UNITED STATES PATENT AND TRADEMARK OFFICE

Office Action Summary

10/713,369

FIG. 4D

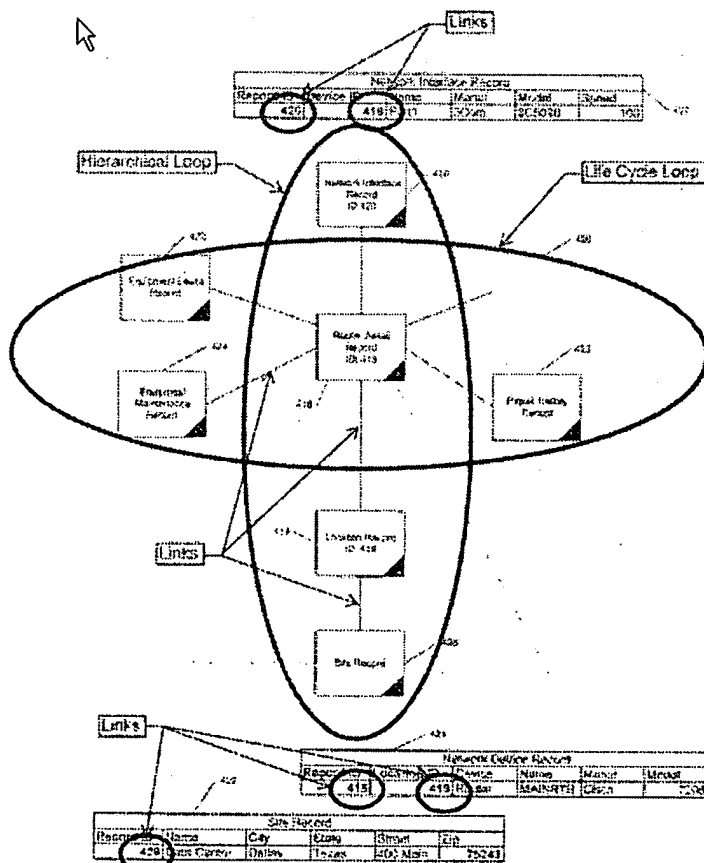
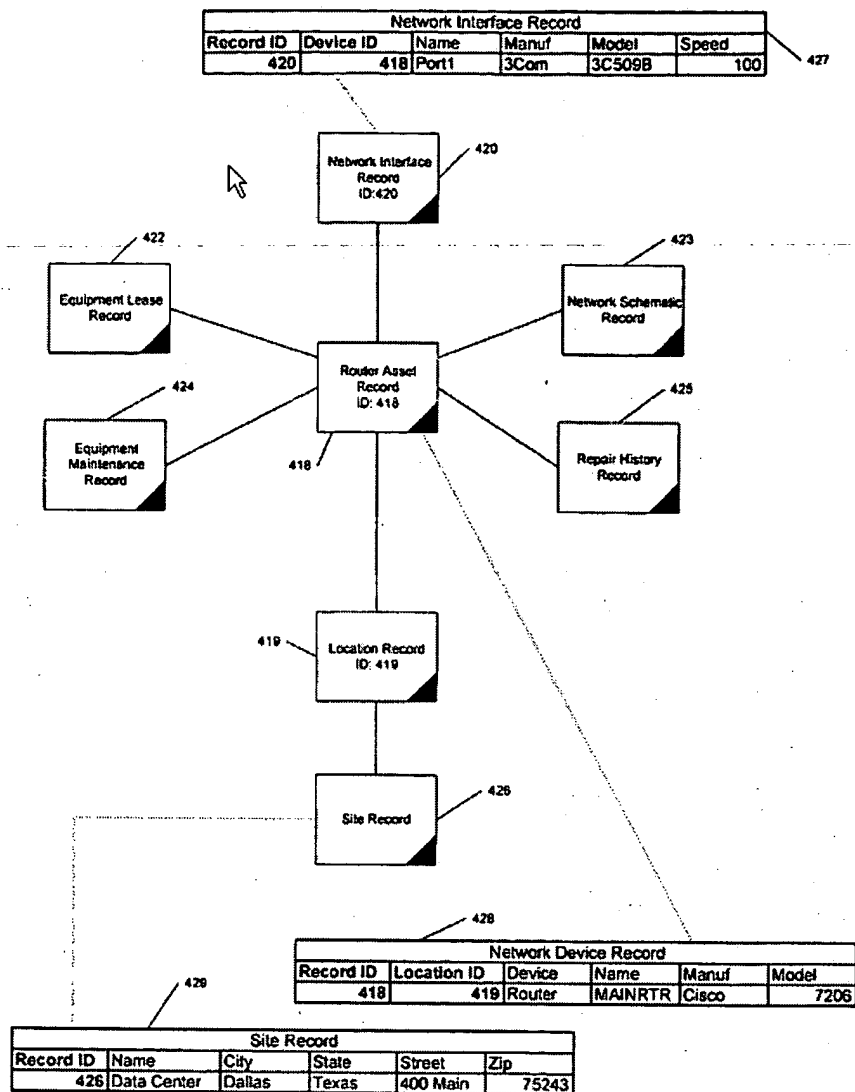
Applicant's arguments are primarily directed to drawing of FIG. 4D which proposes to explain the concepts of the "dual core loop", "hierarchical loop", "life cycle loop" and links. The explanatory drawings provided by applicant look like this:

The originally filed version of FIG. 4D looks like this:

The discussion of FIG. 4D in the original disclosure states the following:

-) [0069] Take the example of the router asset record 418 in FIGURE 4D. This information record is interconnected with several other information records 419, 420, 422, 423, 424, 425. There is a closed-loop around this data element, where removal of the router data record 418 affects the associated interrelated information records. As mentioned earlier, many other asset management systems focus on auto-discovery or auto-location techniques to identify the existence of an asset. Take for instance the router associated with the router asset record 418. This data record is related to a location record 419, which is in turn related to a site record 426. From the hierarchy defined by the ID pointers in the data records, you can determine that Router ID #418 is in Location ID #419, which is located in the Data Center, at 400 Main, Dallas, Texas. There is no need to auto-discover the location of asset devices with my invention, where asset information is stored in a closed-loop hierarchical fashion.

As seen by comparing applicant's explanatory drawings to the original drawings and original specification text, there is no support in the original drawings or specification for dual closed loops, hierarchical loops, life cycle loops or links between two loops. The original disclosure at paragraph 0069, at best, recognizes only one single loop, but does not state where the loop is exactly located or what the loop circumscribes. The disclosure clearly does not support any concept of having two closed loops or intersecting loops, as well as not recognizing a hierarchical loop or a life cycle loop. Applicant's arguments are therefore moot, since they purport to explain features which are not taught in the original disclosure. Since the same explanatory drawing is relied upon to address both statutory rejections under 35 USC 101 and 35 USC 112, these arguments are not persuasive for these particular rejections.
